Service Letter No. 305

October 1, 1958

MODEL AFFECTED: PA-24 Comanche, Serial Numbers Listed Below

DOOR LATCH MODIFICATION	
SKETCH "A"	S. L. #305
PIPER AIRCRAFT CORPORATION	
LOCK HAVEN, PENNSYLVANIA

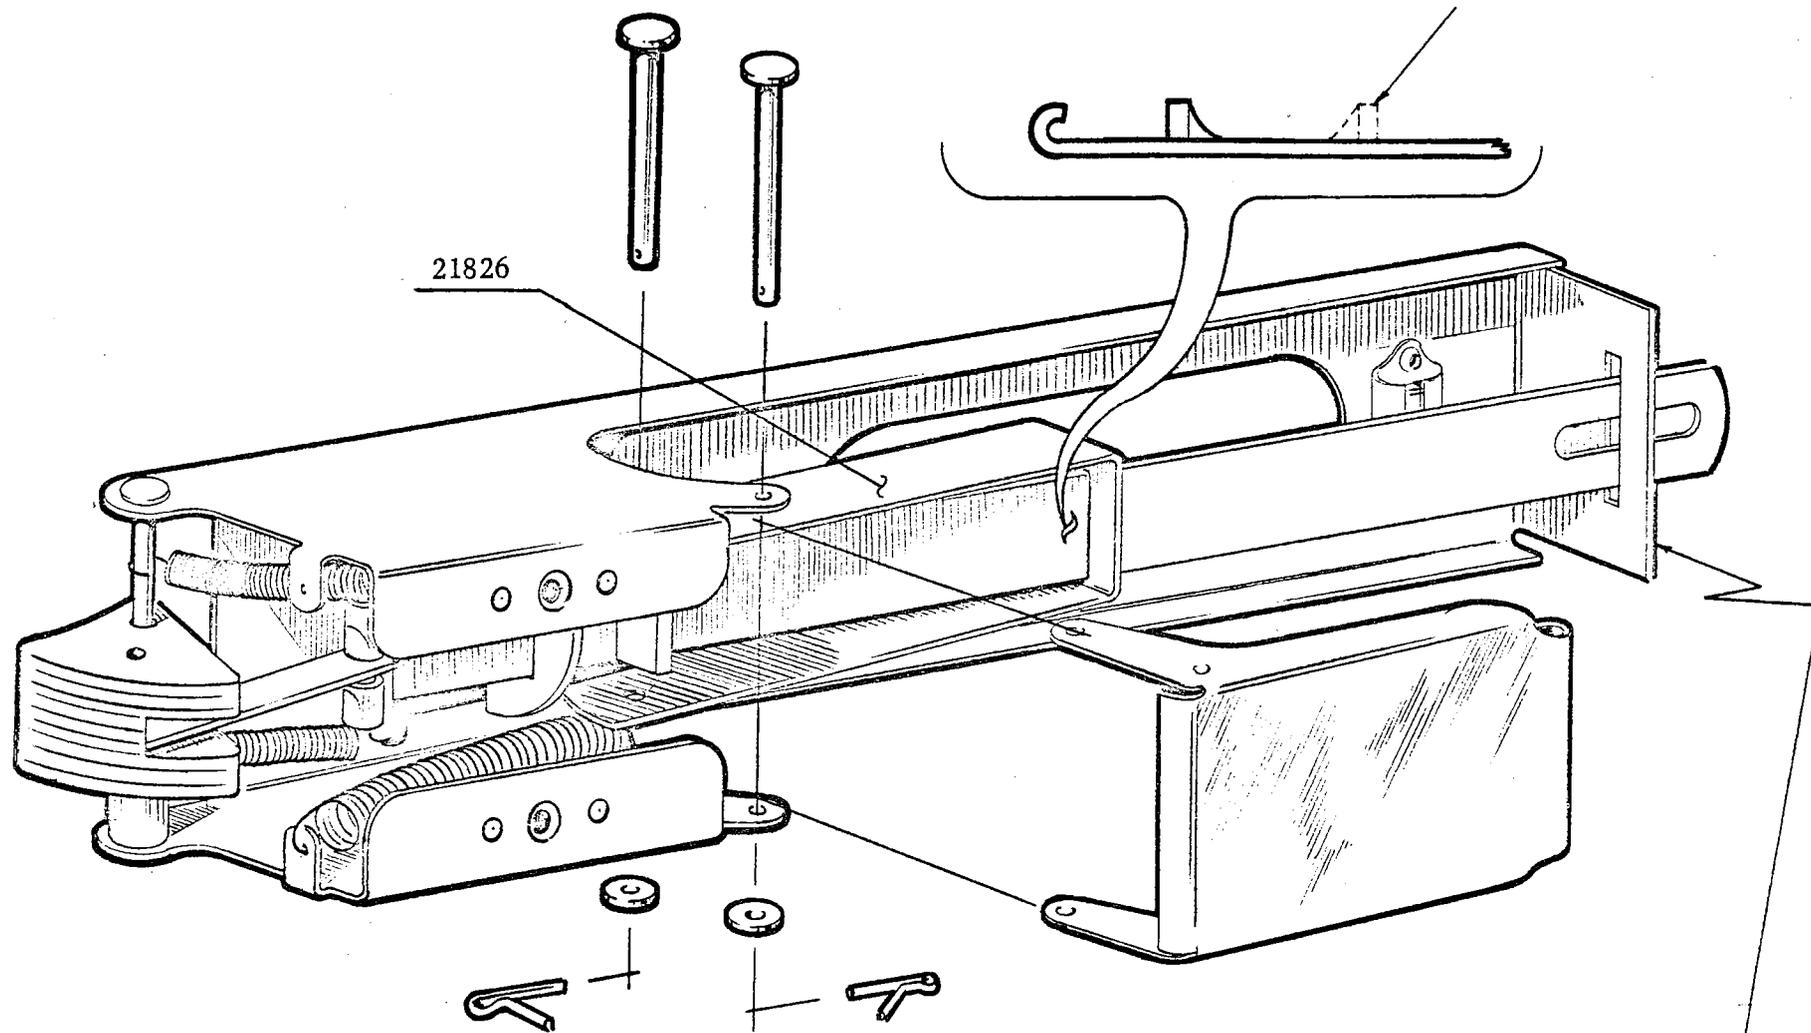
1. The main cabin door latch has been modified to provide a positive means of opening the door from the inside when it has been locked from the outside. We suggest that your door be revised as follows. Remove door latch assembly by loosening door trim upholstery and removing screws attaching latch plate and latch assembly to door frame. Disconnect latch pull rod from inside door handle and remove complete latch assembly. Modify latch assembly per Sketch "A" attached to this letter and install a new part number 21826.

BEND BACK TO LIBERATE
 END OF ACTUATING PLATE
 TO INSTALL PART NO. 21826

OIL SEPARATOR INLET HOSE MODIFICATION	
SKETCH "B"	S.L. #305
PIPER AIRCRAFT CORPORATION	
LOCK HAVEN, PENNSYLVANIA

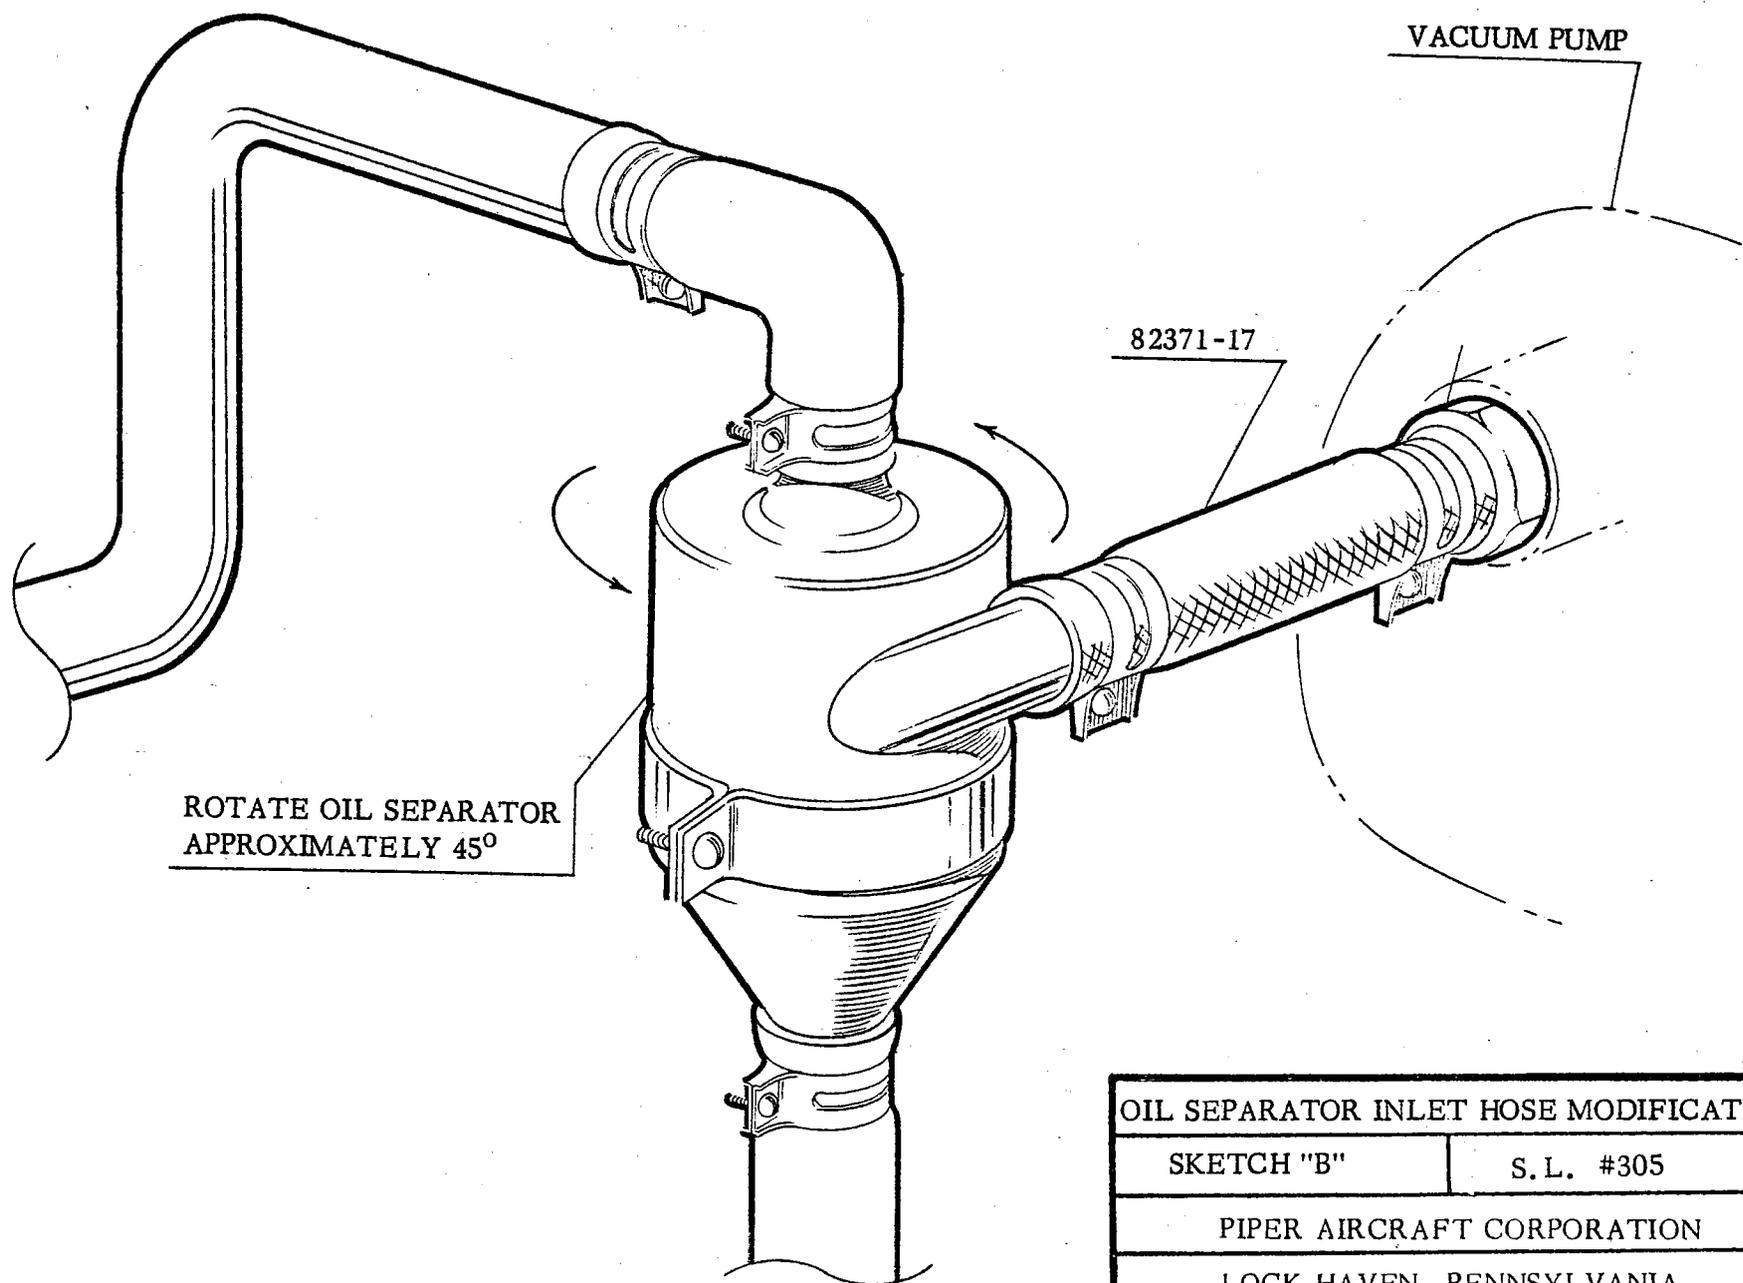
2. Rotate oil separator and install new hose part number 82371-17 and hose adapter part number 451 861 (AN840-9D) per Sketch "B" attached to this letter.

ROTATE OIL SEPARATOR
APPROXIMATELY 45°

L. G. Retraction Tube Arms Modification	
SKETCH "C"	S. L. #305
PIPER AIRCRAFT CORPORATION	
LOCK HAVEN, PENNSYLVANIA

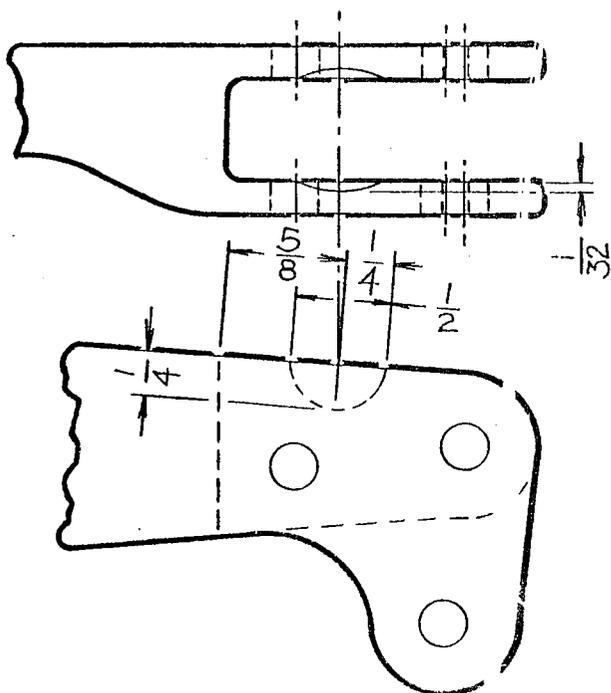
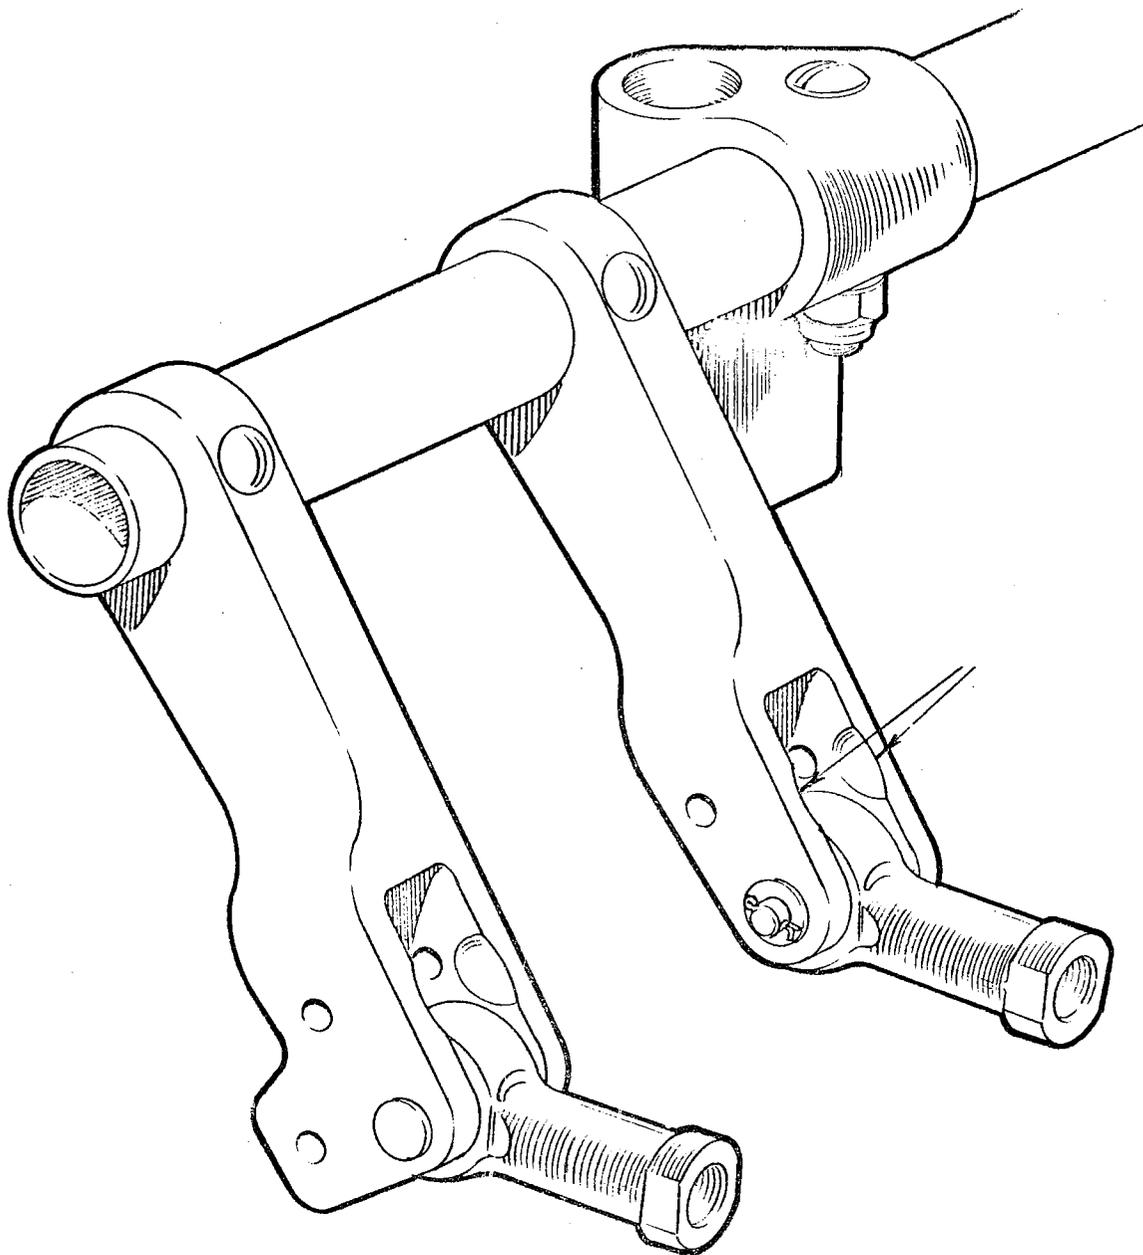
4. To prevent interference between the landing gear retraction tube arms and the retraction tube rod end bearings, the arms shall be modified per Sketch "C" attached to this letter.
